MOUNT PEAKE PROJECT

ADDENDUM TO THE DRAFT ENVIRONMENTAL IMPACT STATEMENT

Wilora, Northern Territory

Animal Plant Mineral Pty Ltd

Figure 2-2: Process Facilities General Arrangement

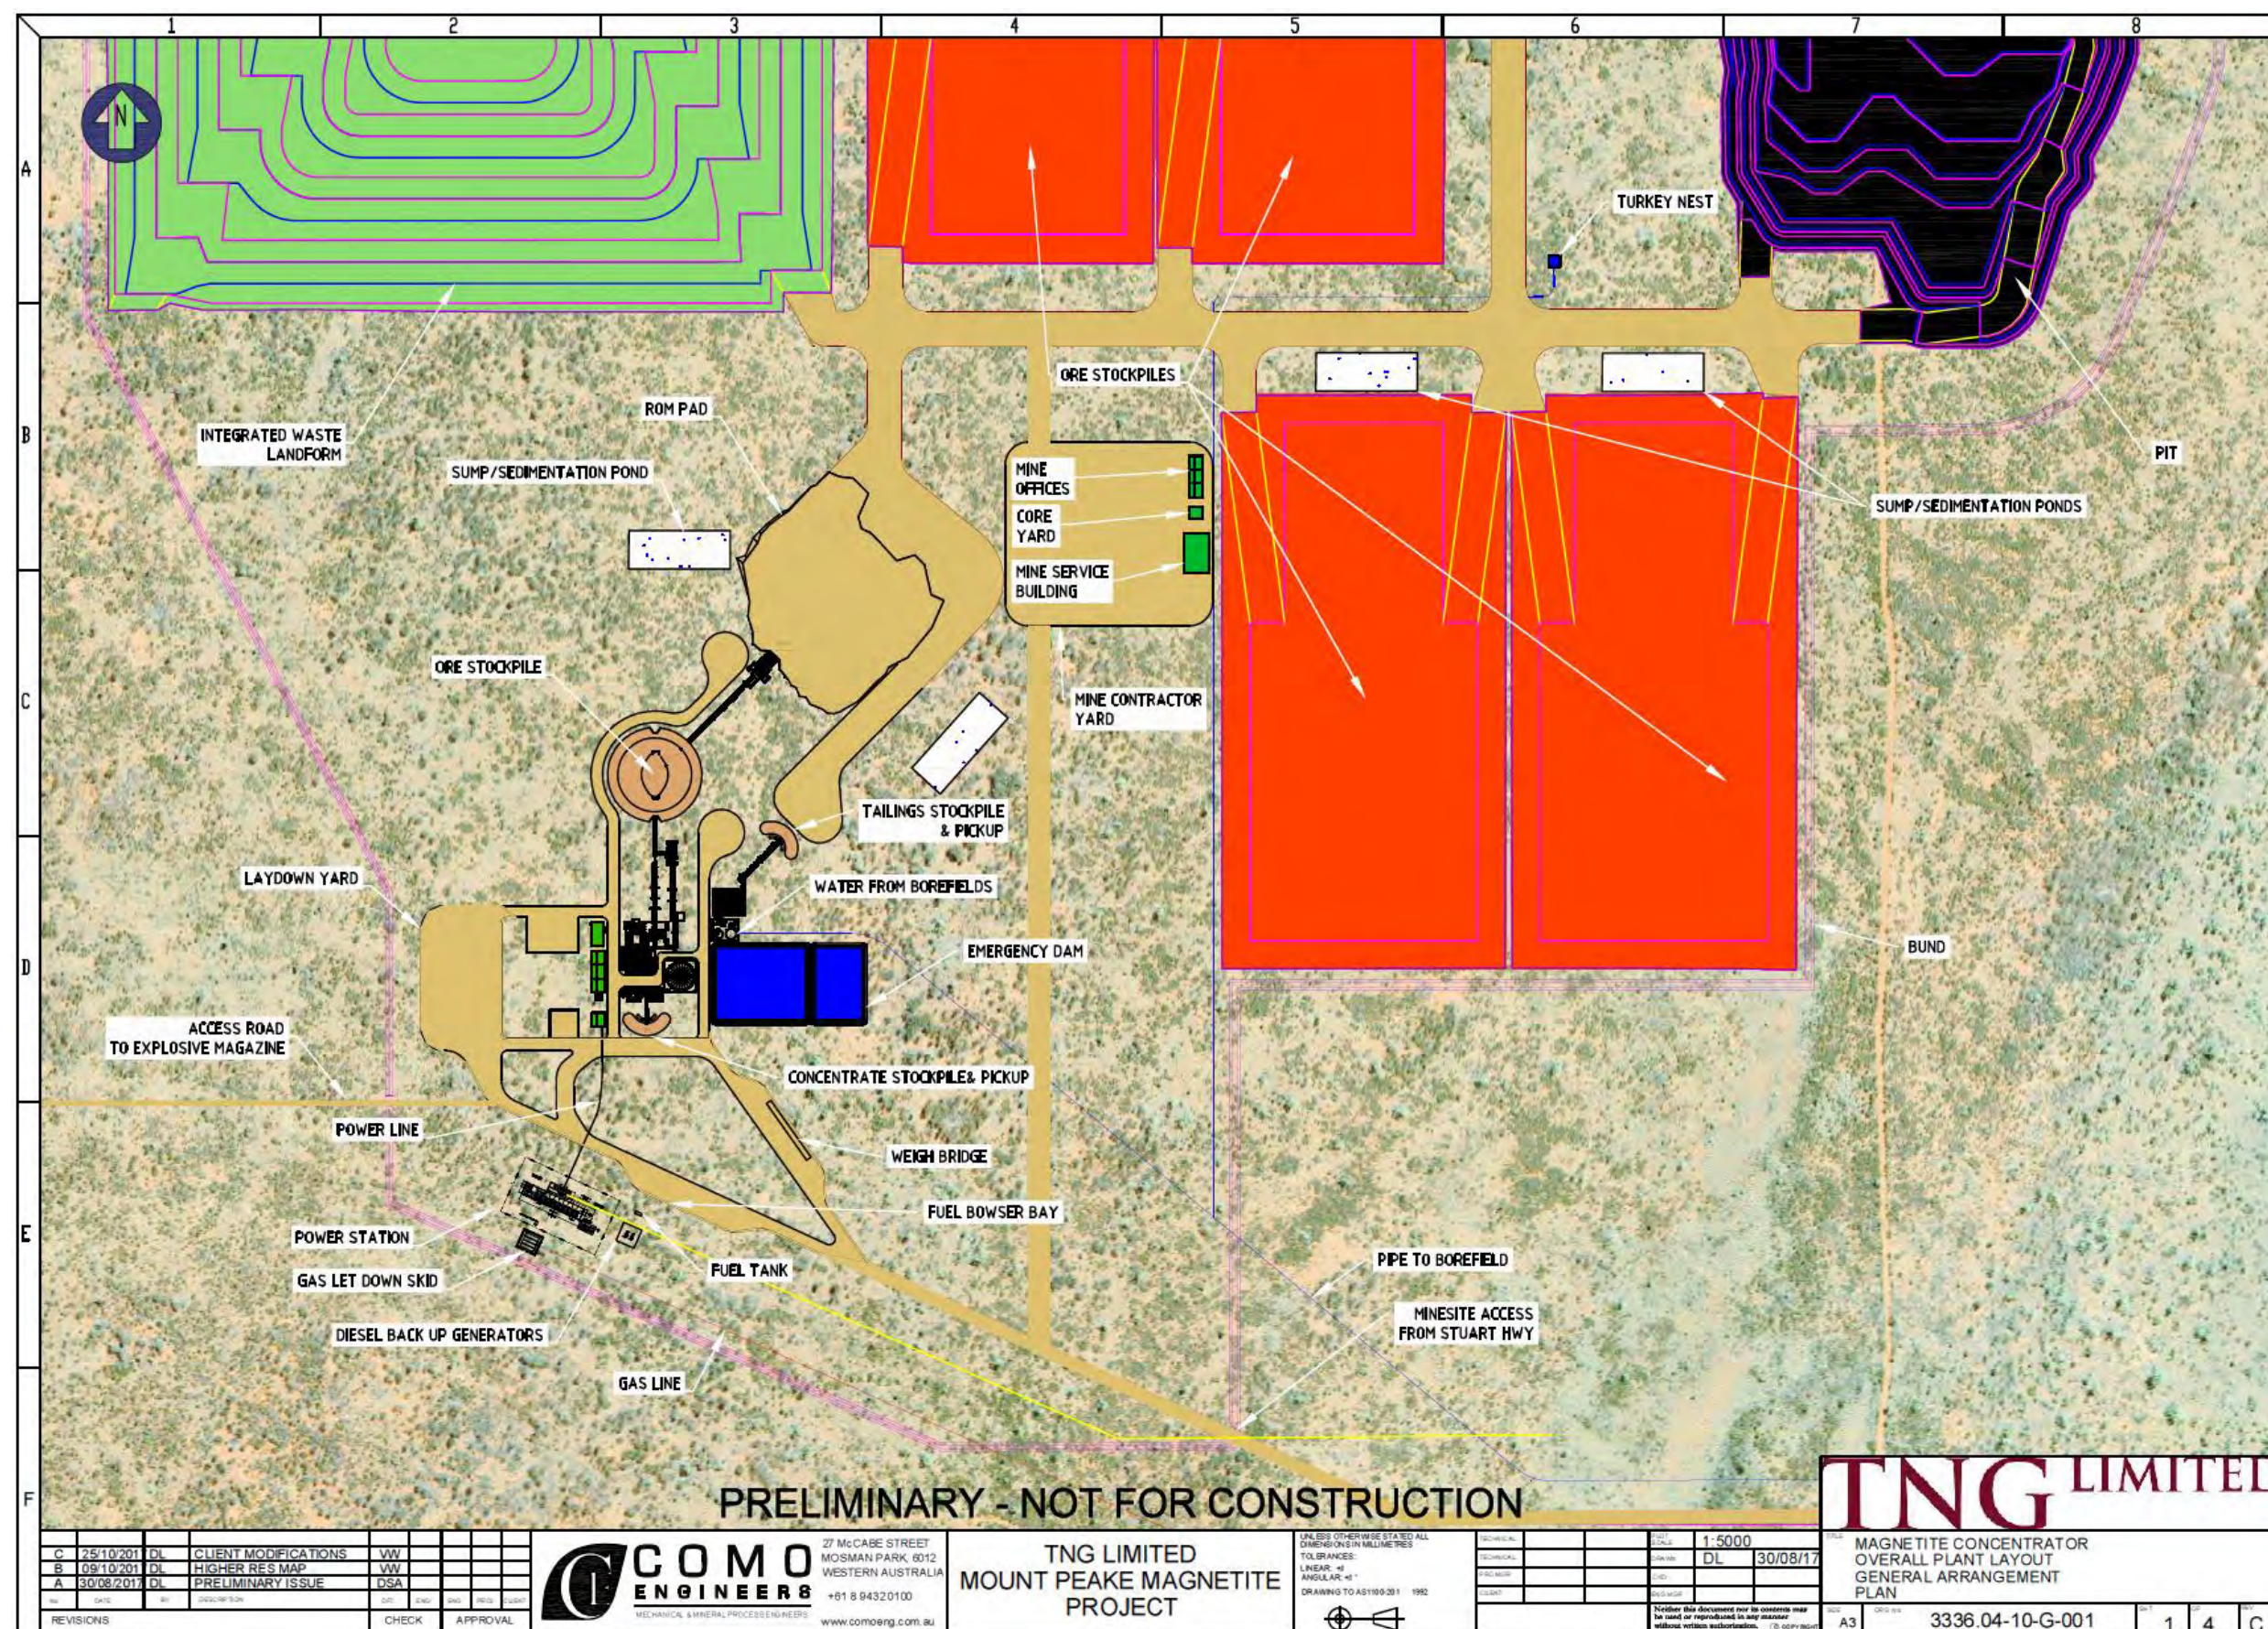
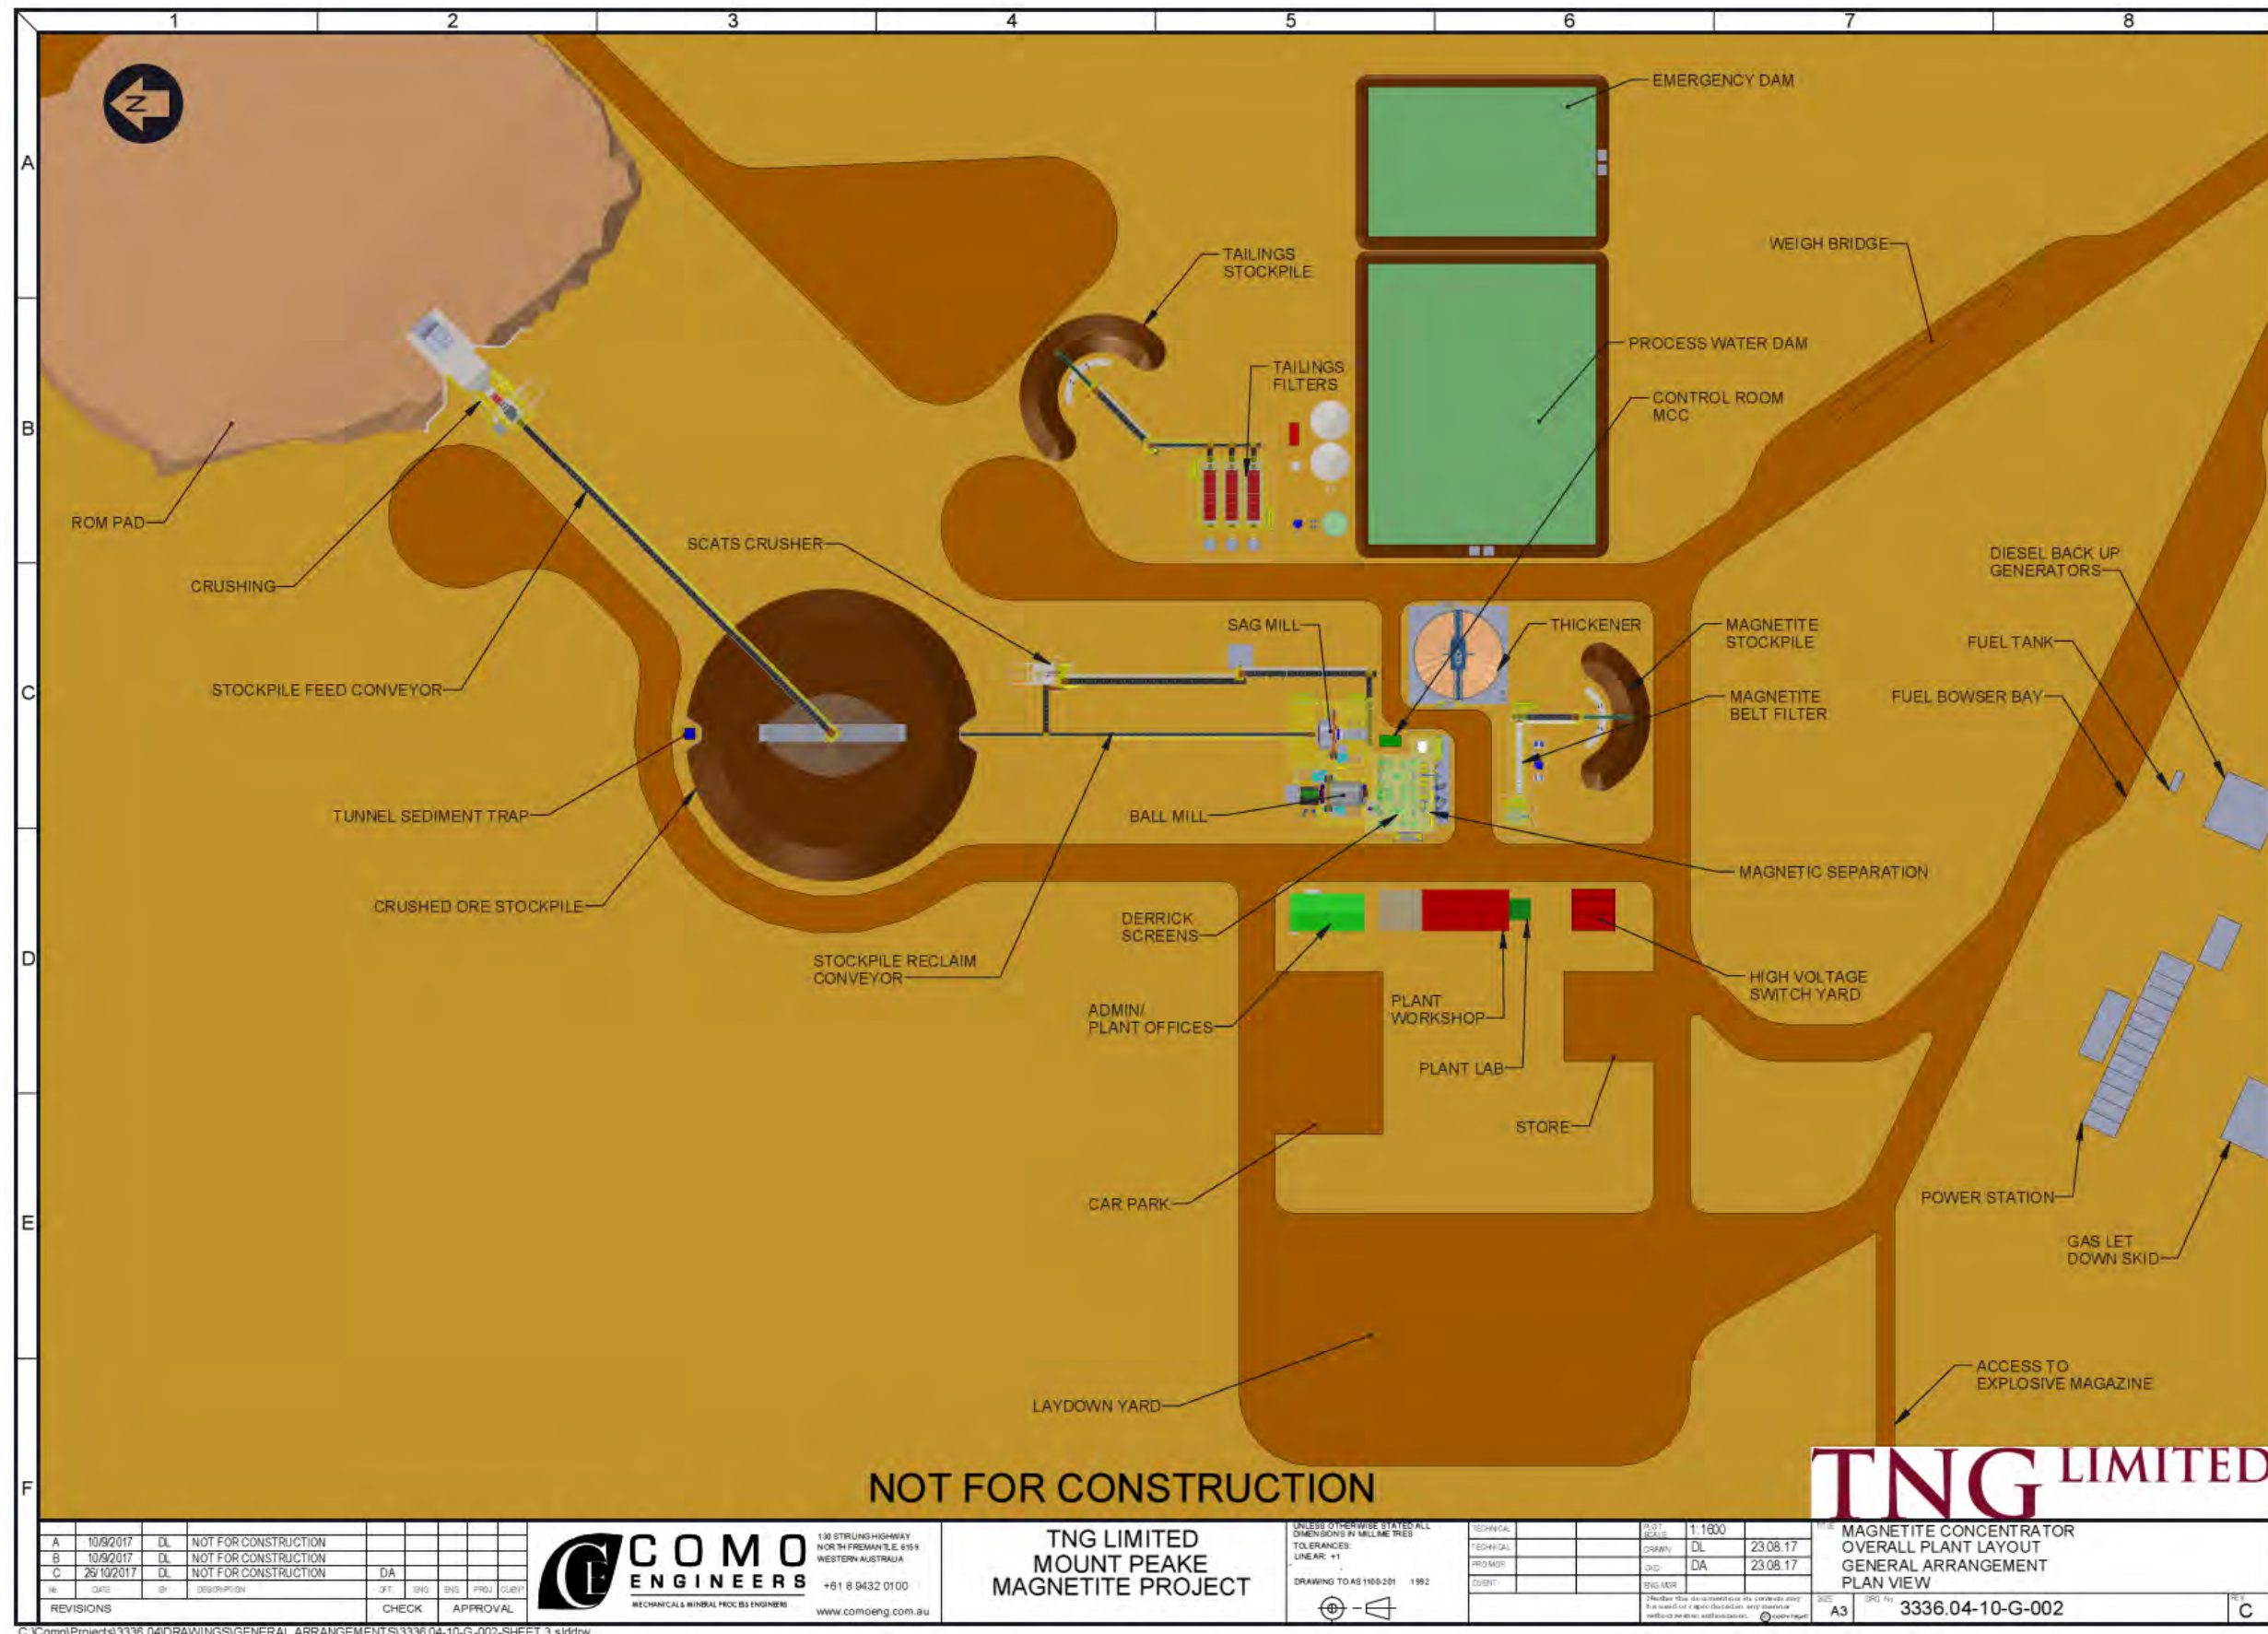
Layouts of the processing facilities are shown in Figure 2-1 and Figure 2-2 and a simplified process diagram is shown in Figure 2-3. Table 2-1 below identifies processing changes from that previously proposed in the Draft EIS.

Circuit	Previous	Current
Crushing	Two-stage crushing to P80=30mm.	Single stage crushing to P80=150mm. Secondary crushing and cone crushers have been removed.
Grinding and classification	High Pressure Grinding Rolls (HPGR) and ball mill.	SAG, ball mill and pebble crusher (SABC) configuration. Add SAG mill and second ball mill.
Magnetic Separation	Rougher and two-stage cleaner Low Intensity Magnetic Separator (LIMS).	Add Reflux Classifier (RC) after cleaner LIMS to remove silica.
Non-Magnetic Tailings	Thickened and pumped as slurry to TSF.	Filtered dry stack. Add Belt filter after thickener for dewatering tails. Filter cake is stockpiled and trucked to IWL.

Figure 2-3: Process Flowsheet

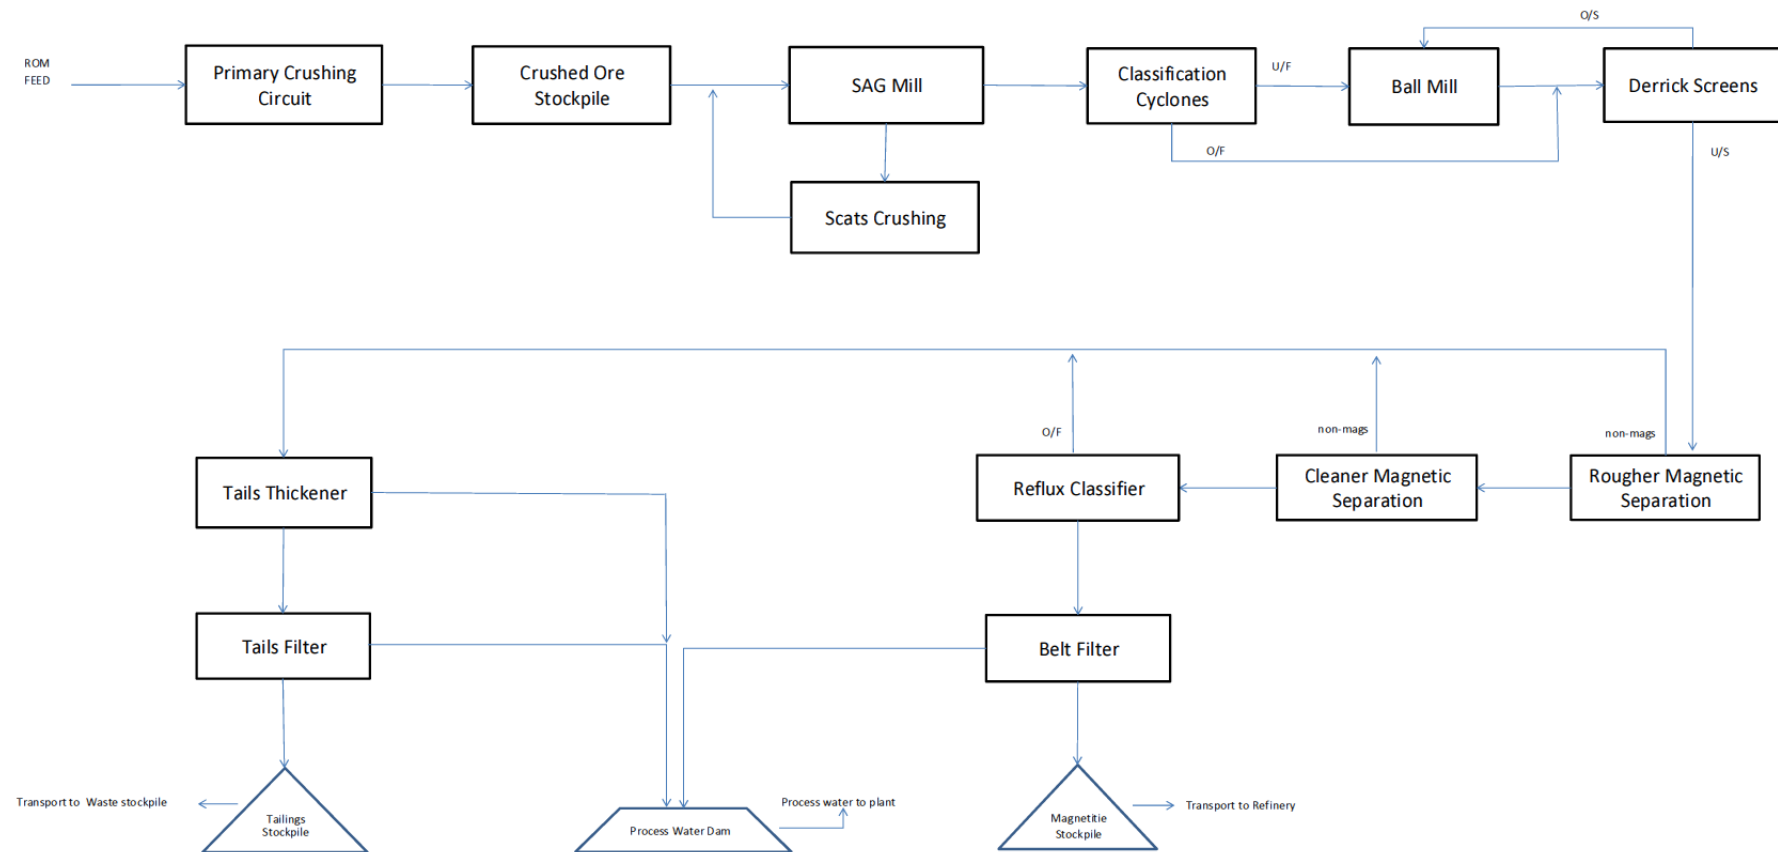
Alteration of tailings management from a TSF to co-disposed dry-stack tails within an IWL is a significant change for the Project. Whilst a TSF with a central discharge tower (CDT) presented an economic solution for tailings management, the TSF required water to be added to the tails stream in order that a slurry of 65% w/w was created and could be pumped to the facility. It was recognised that there was risk around the ability to maintain pumping capacity required to pump up the incline ramp of the CDT, the water demand associated with the TSF was significant and the 2.1km diameter footprint for the facility was extensive.
